TOWN OF NISKAYUNA
Planning Board and Zoning Commission
Agenda
May 9, 2022
7:00 PM

ITEM TITLE: DISCUSSION: 2341 Nott St. – ShopRite Plaza – site plan app. for placing a Chase Bank ATM machine in the plaza parking lot

ITEM TITLE: DISCUSSION: 2303 Nott St. E – Starbucks – Application for Site Plan Review for interior and exterior renovations to the shop.

EXISTING CONDITIONS & SITE PLAN

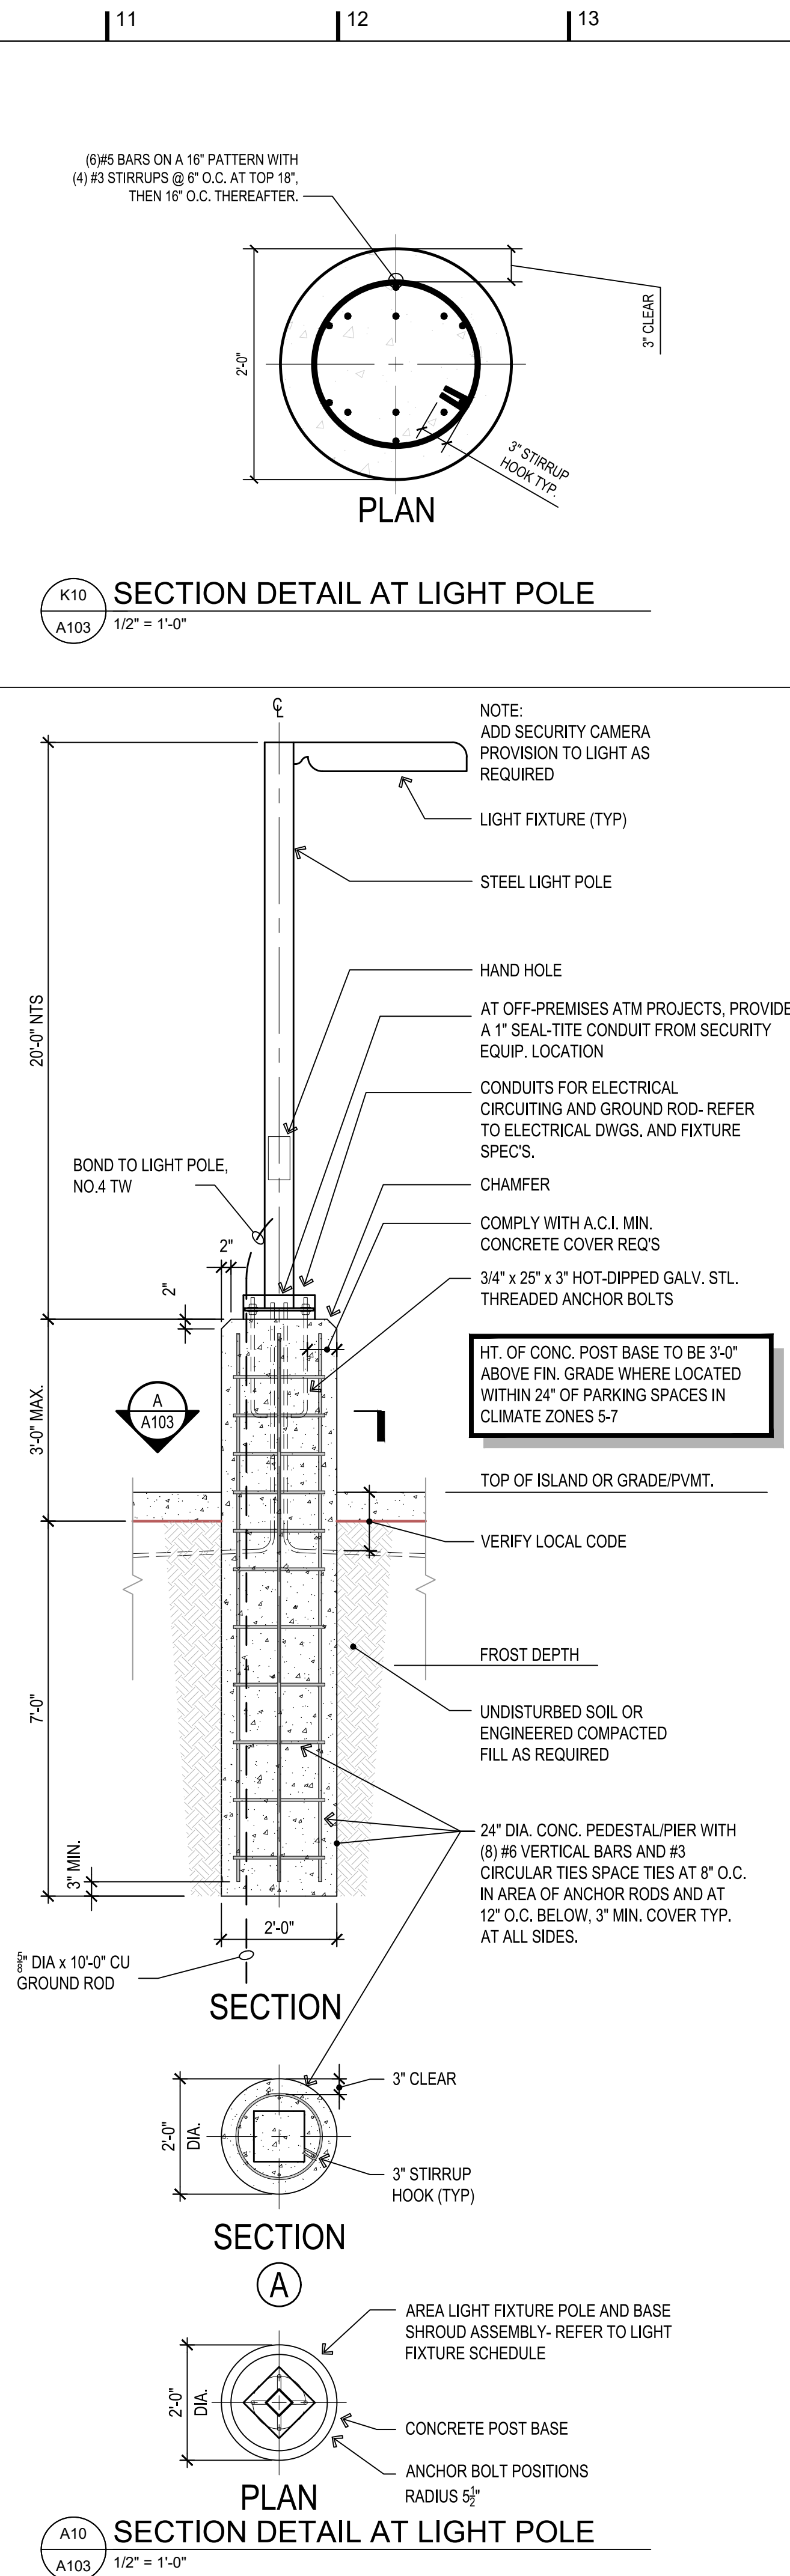
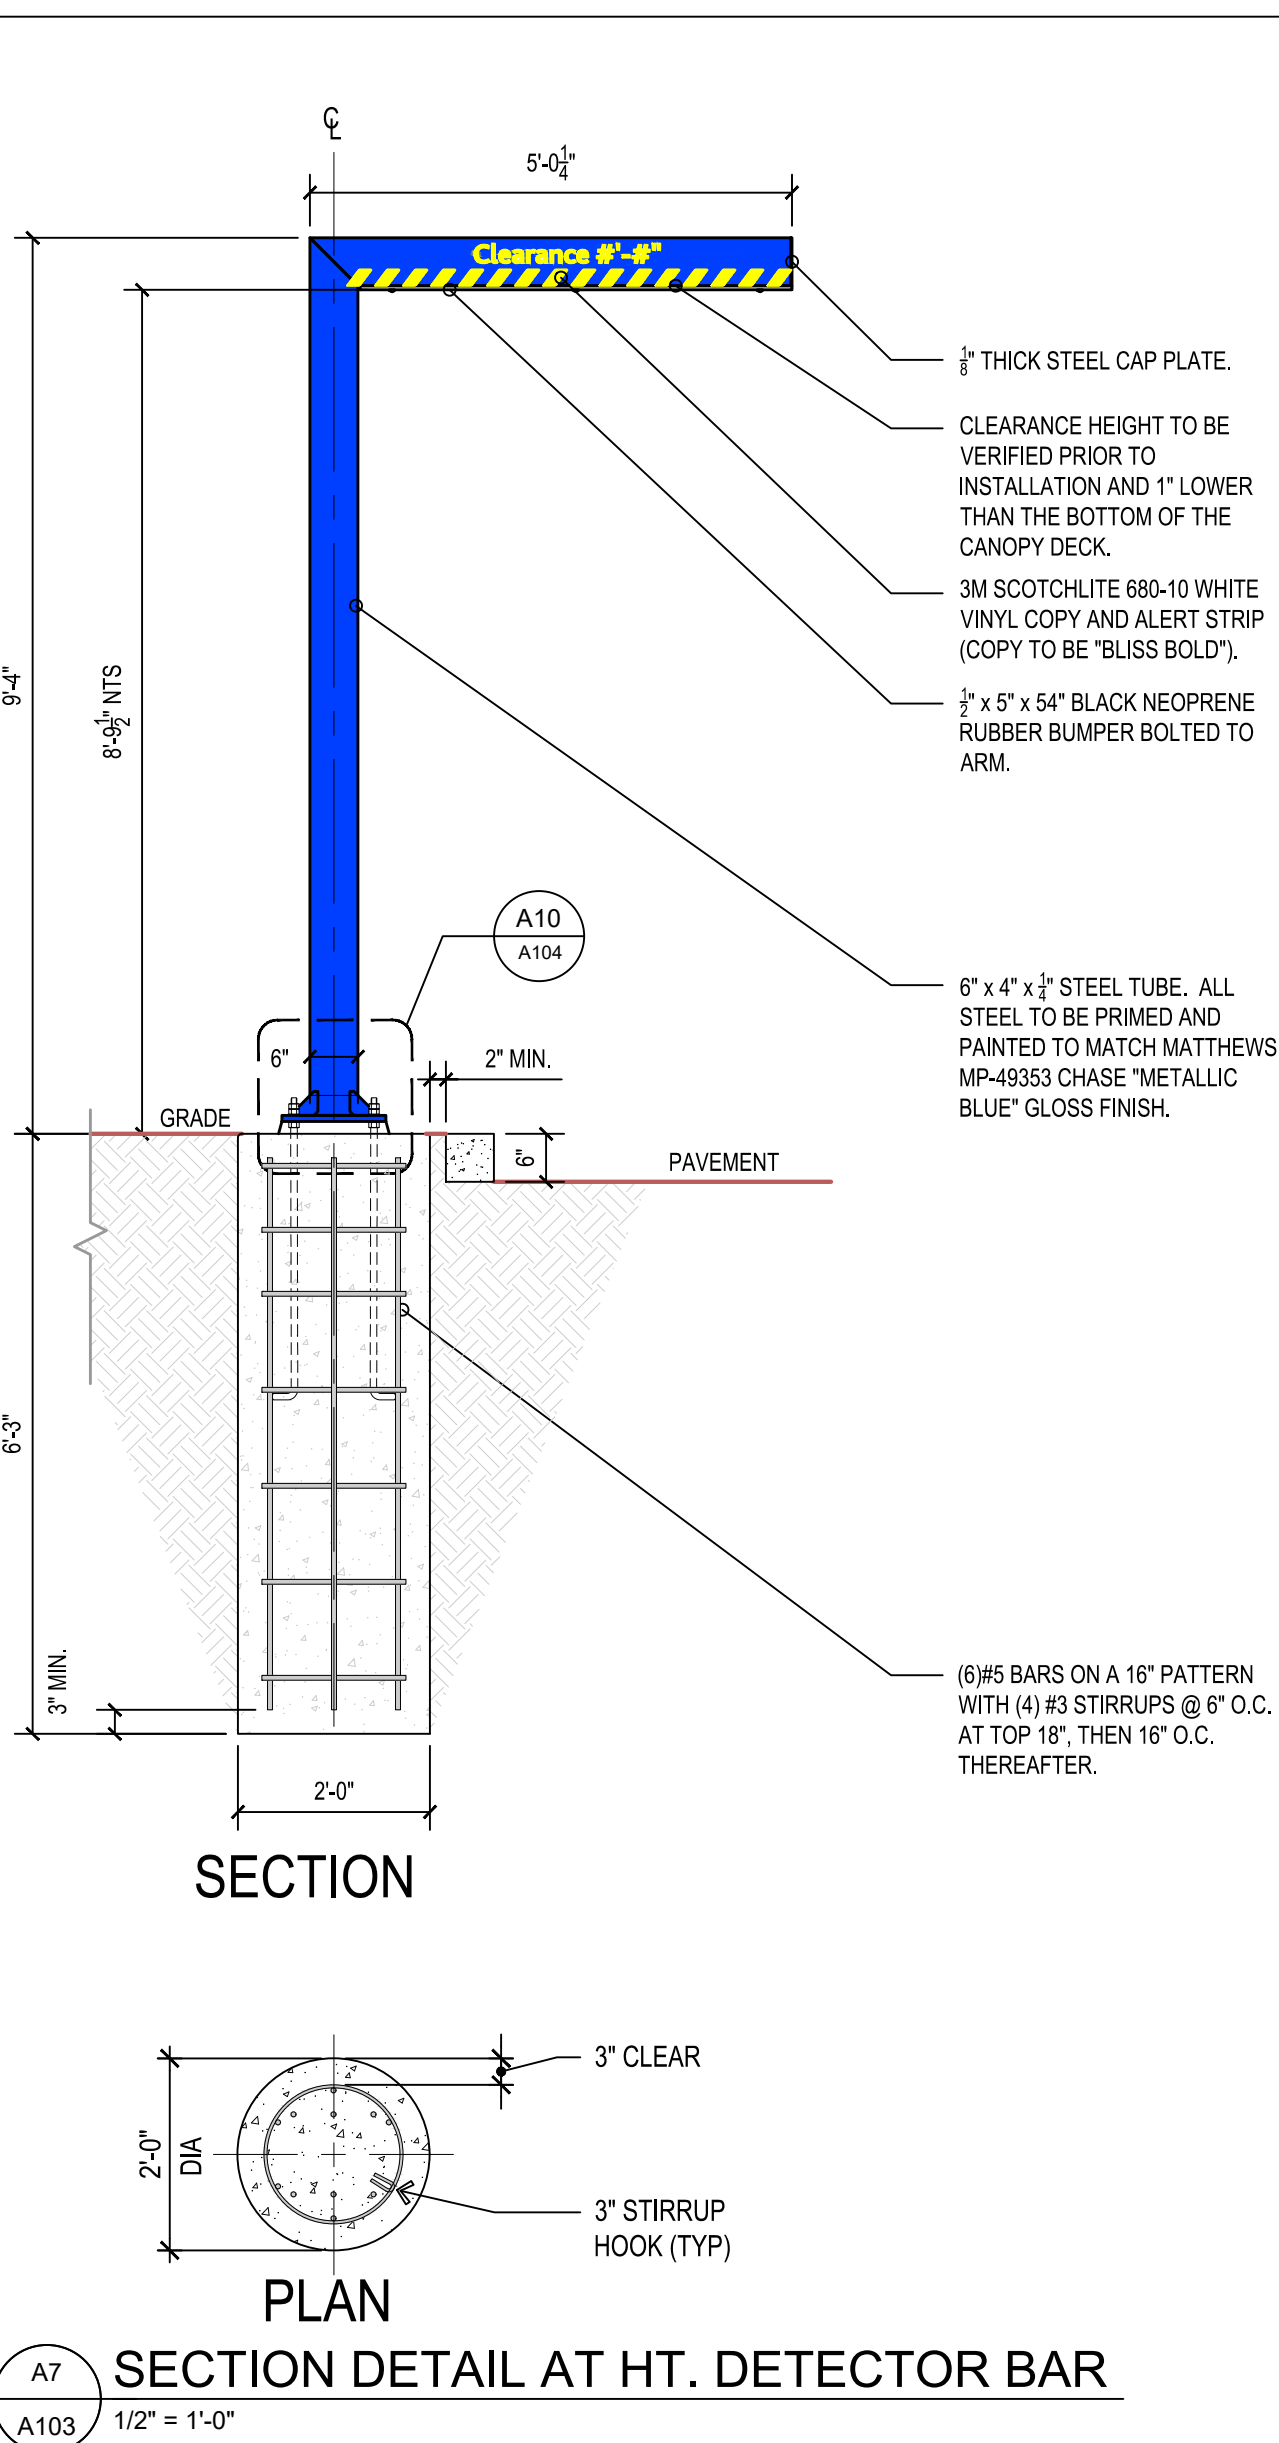
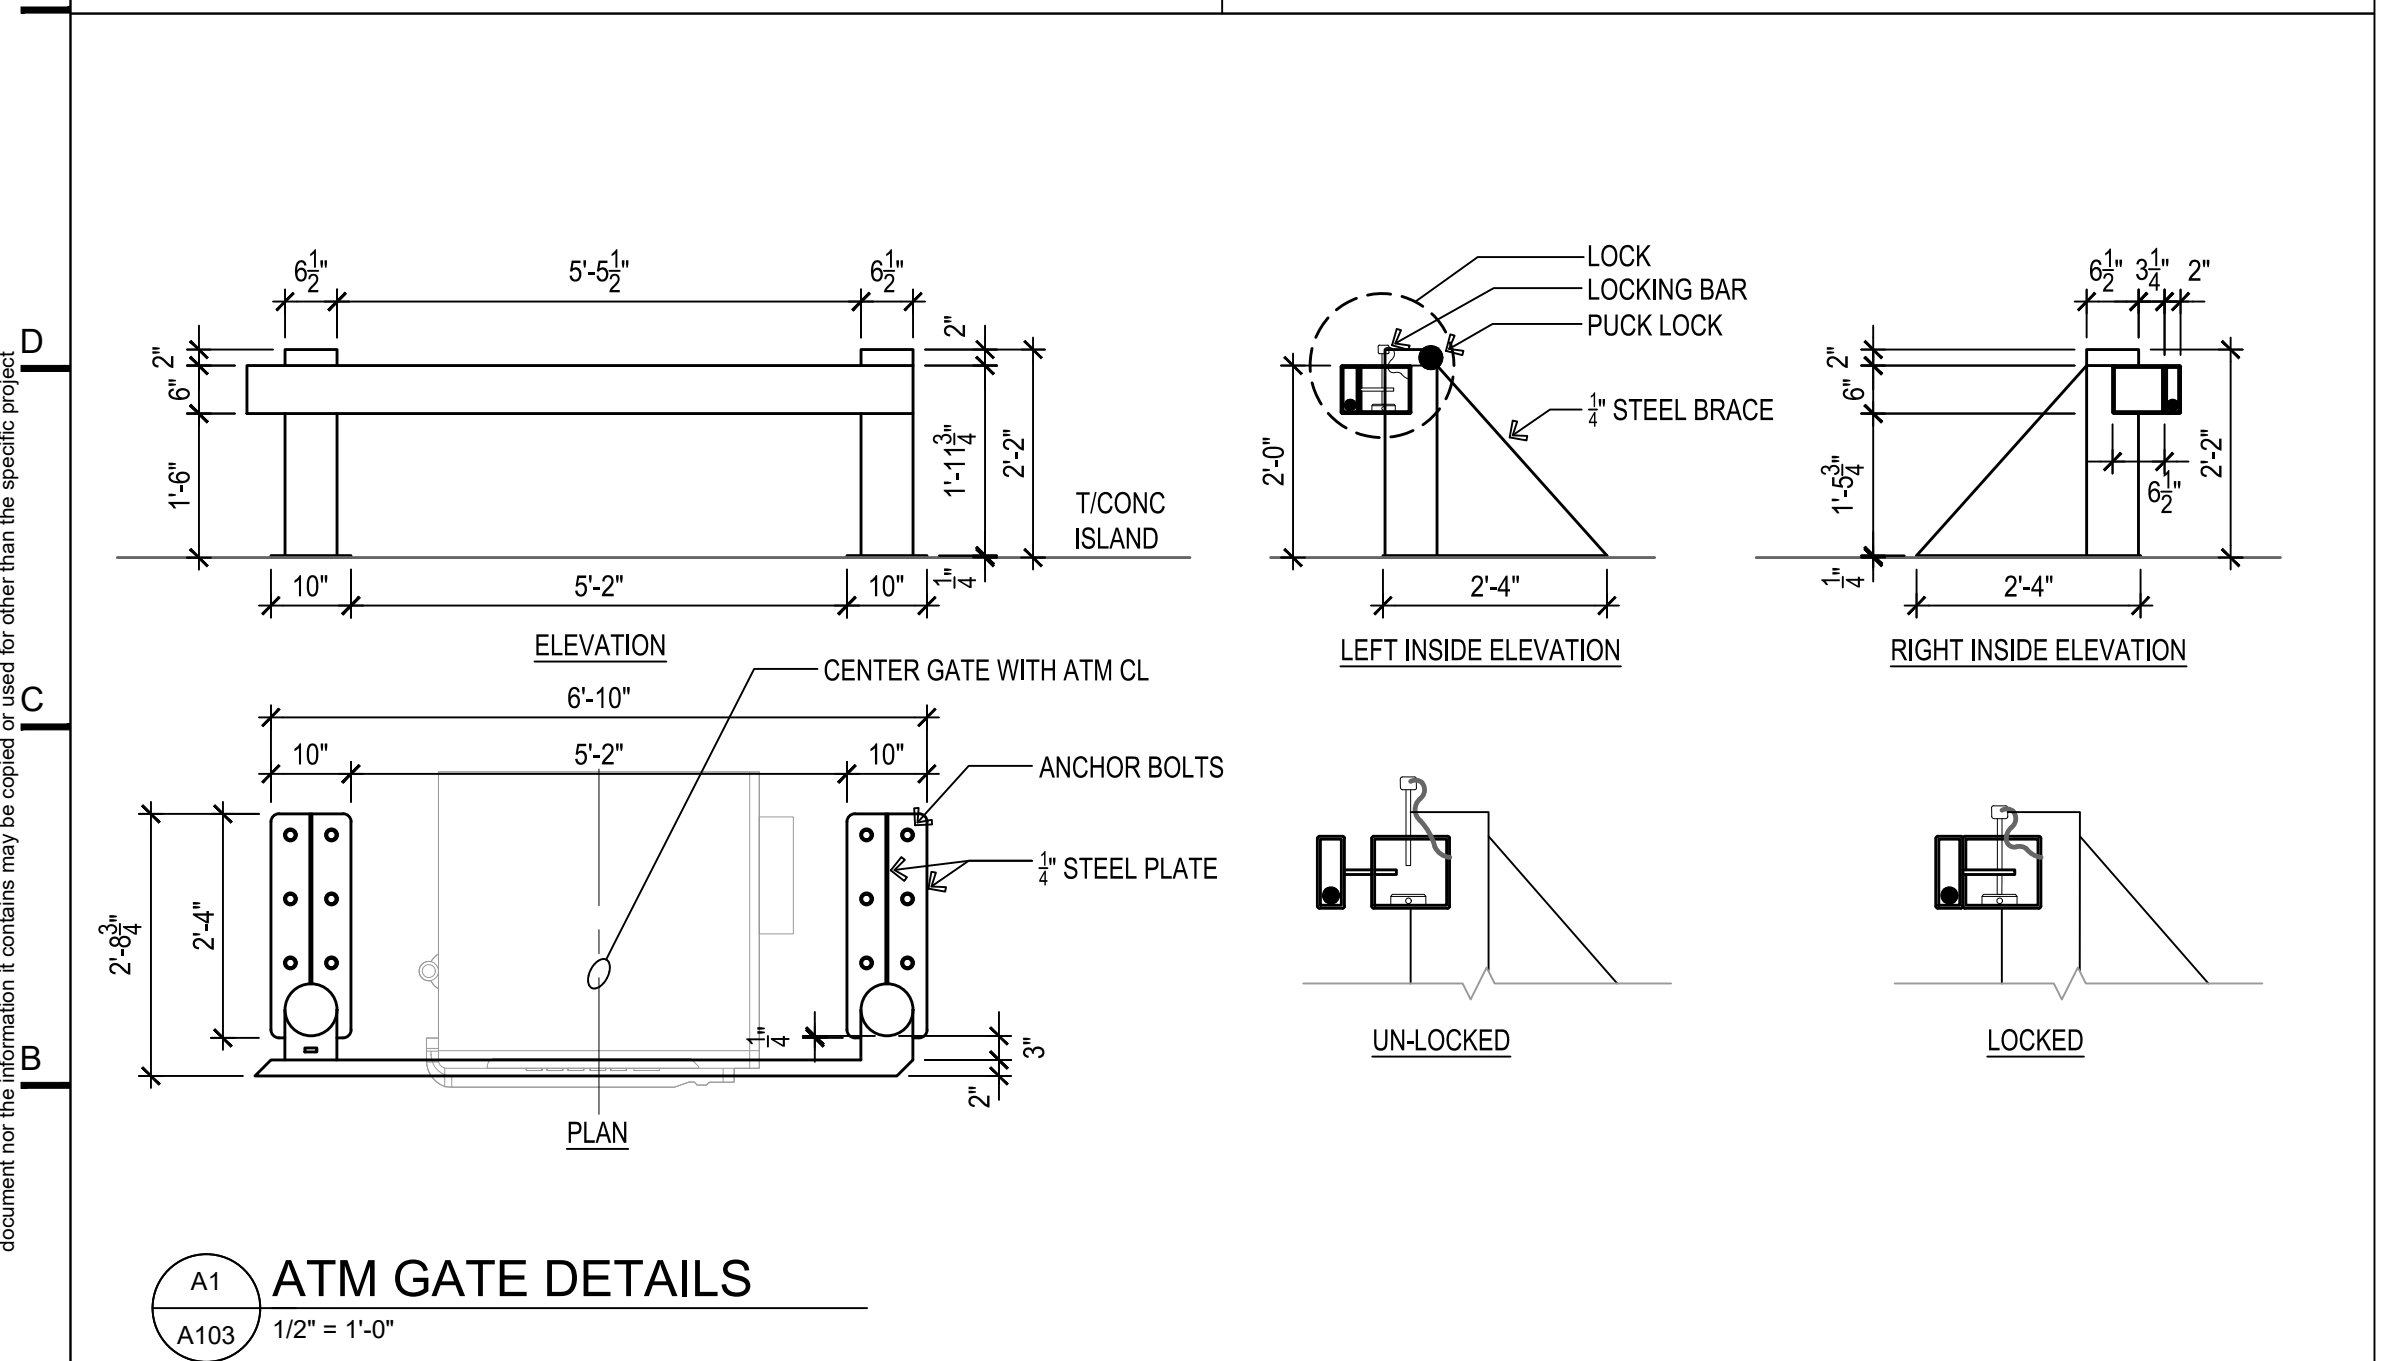
As proposed, page A102 of the drawing set includes a light pole with an area light measuring 23' high (3' high concrete base + 20' high light pole) located at the entrance to the ATM machine. Therefore, a waiver of 1' (23 – 22) of pole height from finished grade is required.

As proposed, page A105 of the drawing set includes a photometric plan of the project area. The area immediately around the ATM is illuminated to approximately 5 fc. The illumination at a 25' radius from the project site is illuminated to approximately 2 fc. The illumination level at a radius of 50' from the project site is typically significantly less than 1 fc and equivalent to the larger parking lot area.

Pages A102, A103 and A104 of the aforementioned drawing set include design details for the proposed ATM. Several portions of the ATM station infrastructure and associated graphical displays should be reviewed by the Board relative to the requirements set forth in Section 220-4 of the zoning code. The drawings include a "non-illuminated signage option" that reads "CHASE" followed by the Chase Bank logo on one of the canopy legs.
